### SECTION 00 91 11 - ADDENDUM NUMBER 3

Date: February 14<sup>th</sup>, 2025  
Project: NGFD English Road Station - Contracts DEFG  
Project Number: 20233530.0001

DRAWING NO.: A-319

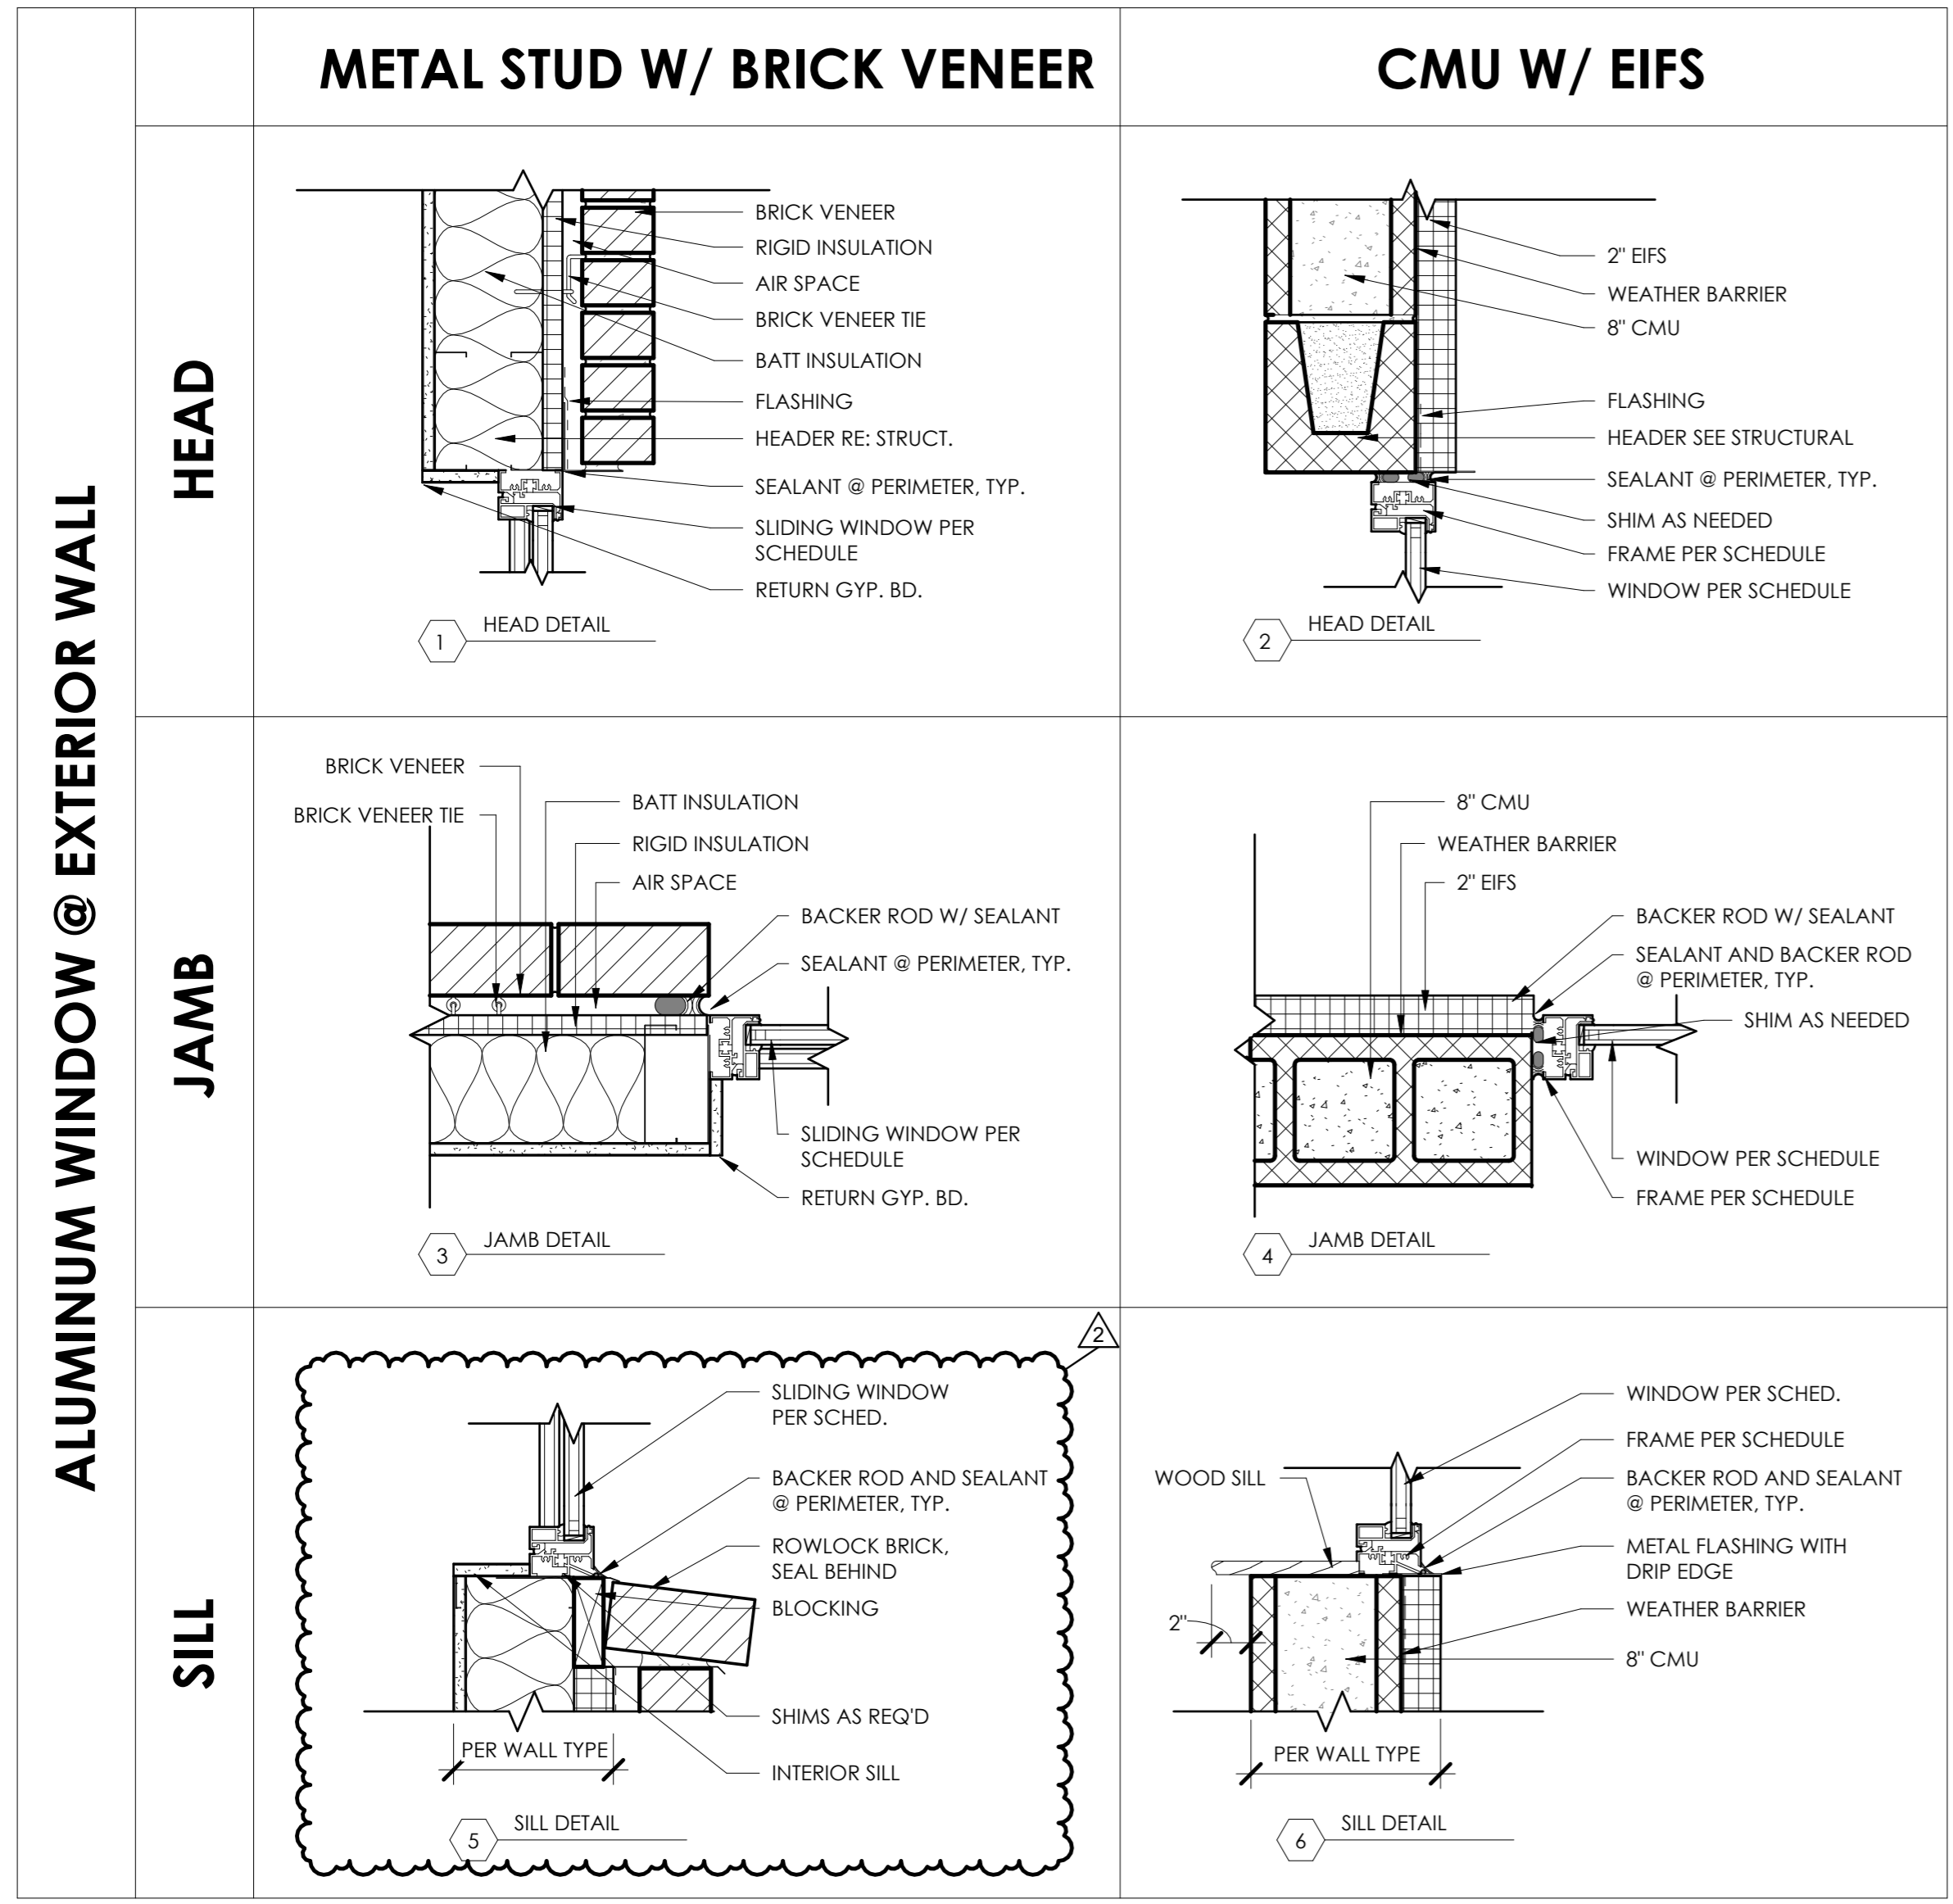
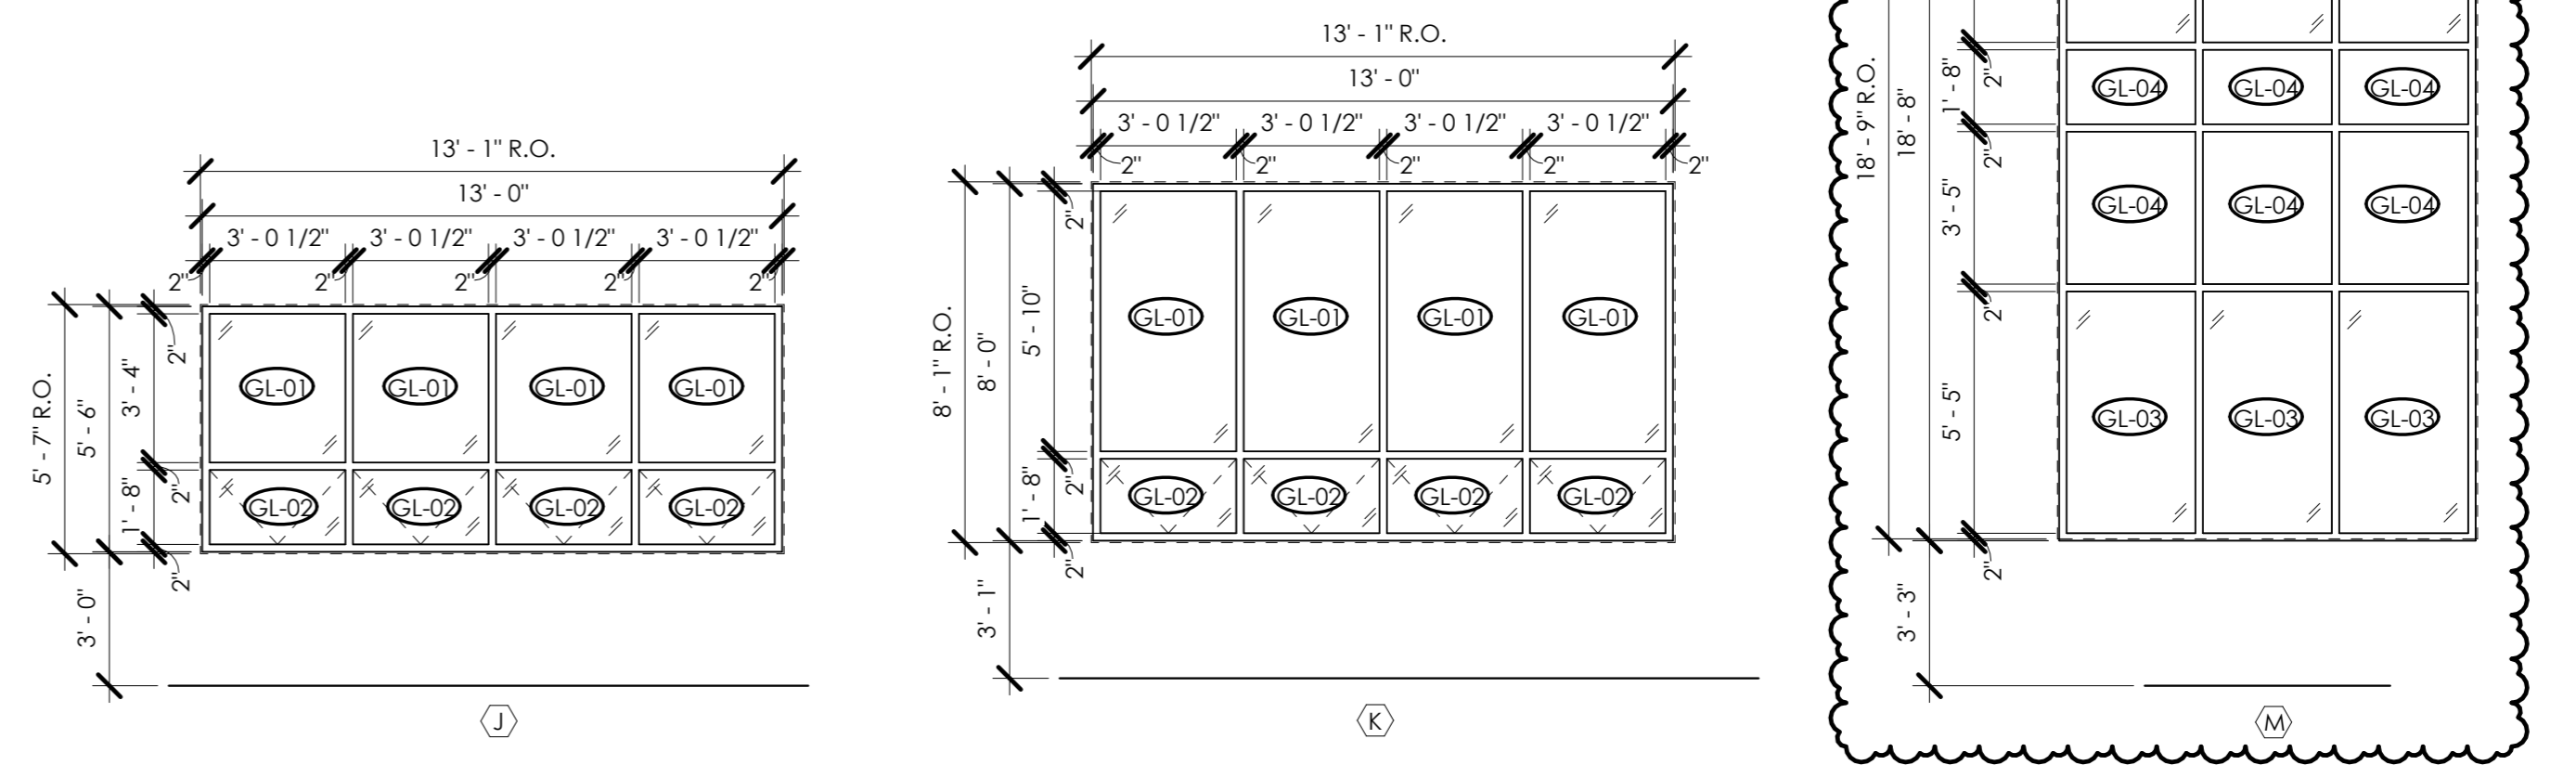
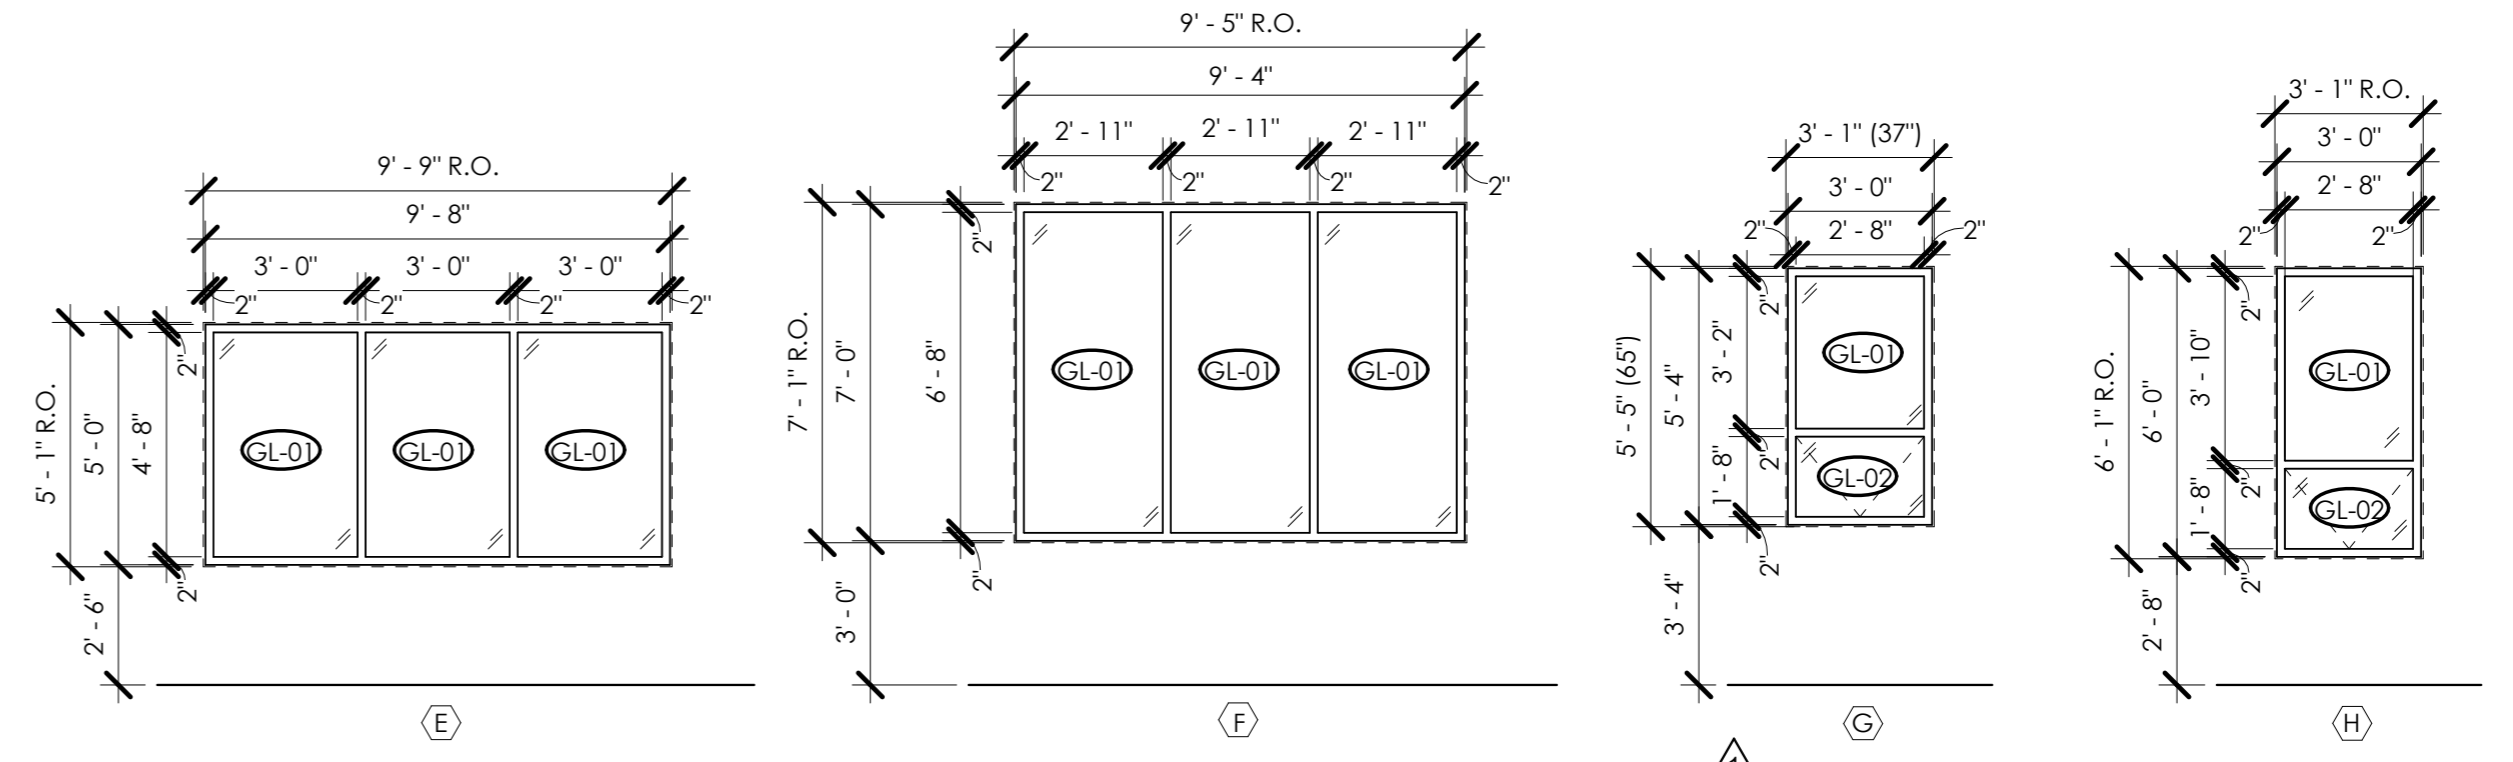
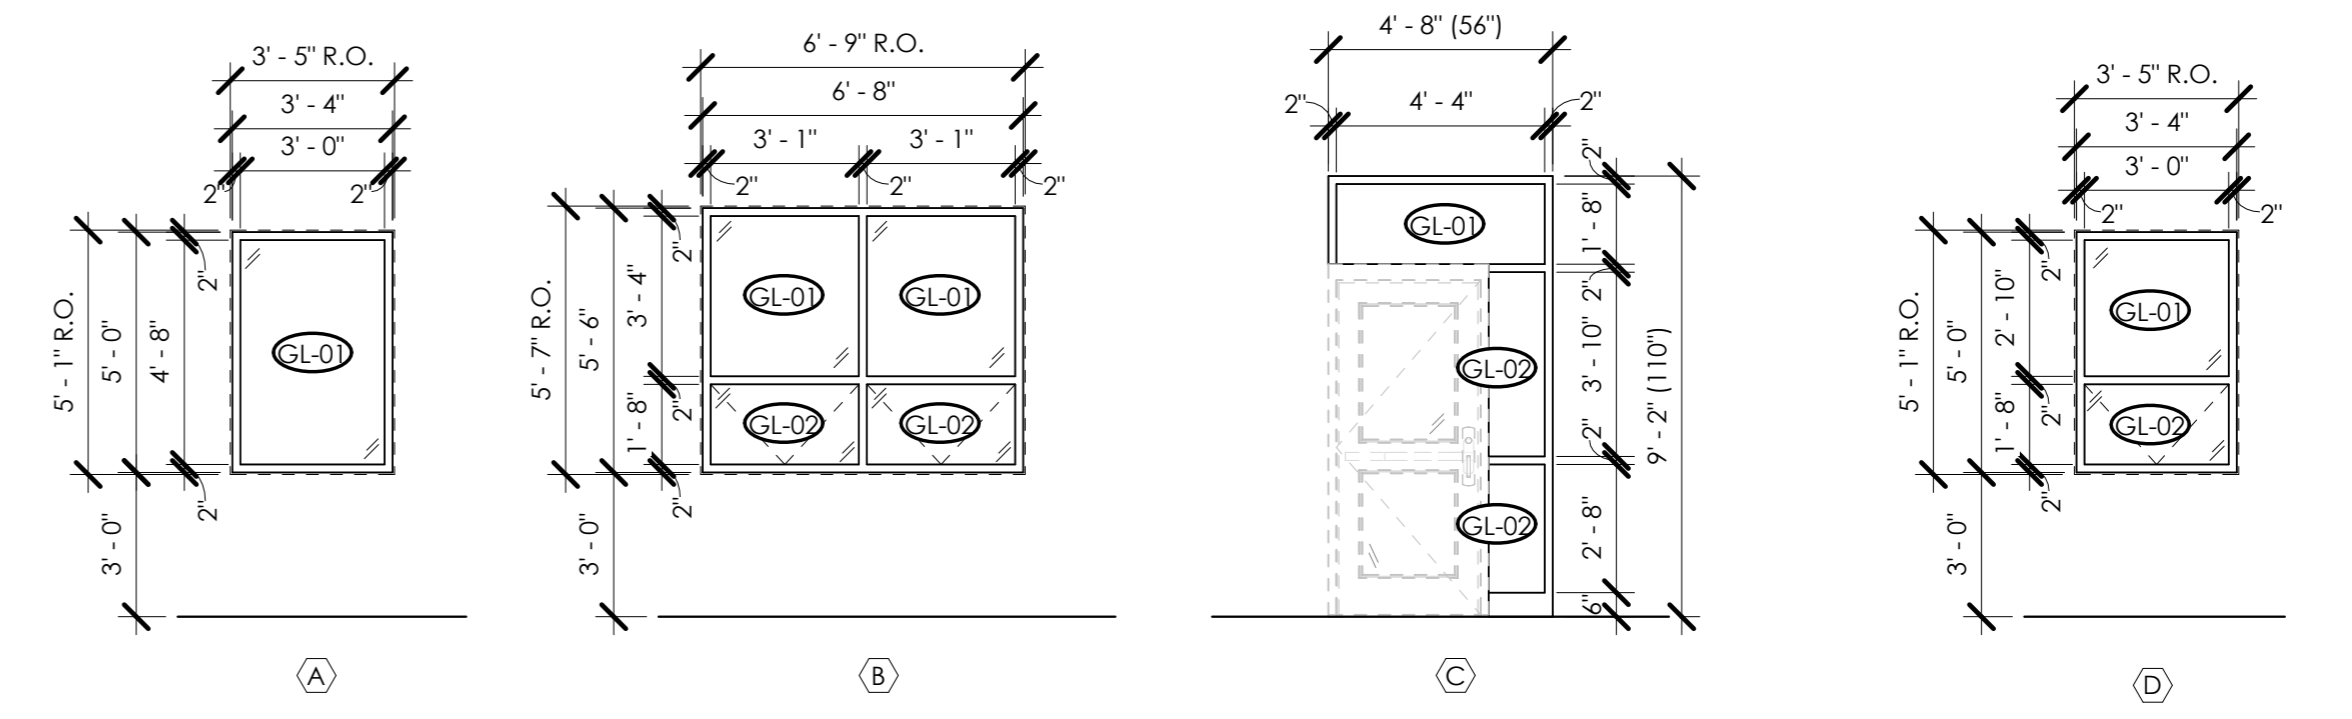
1. A-319 Wall Section Details
  - Revise wording at Detail 4
2. A-602 Window Schedule
  - Revise Sill Detail 5 to properly reflect rowlock brick sill.
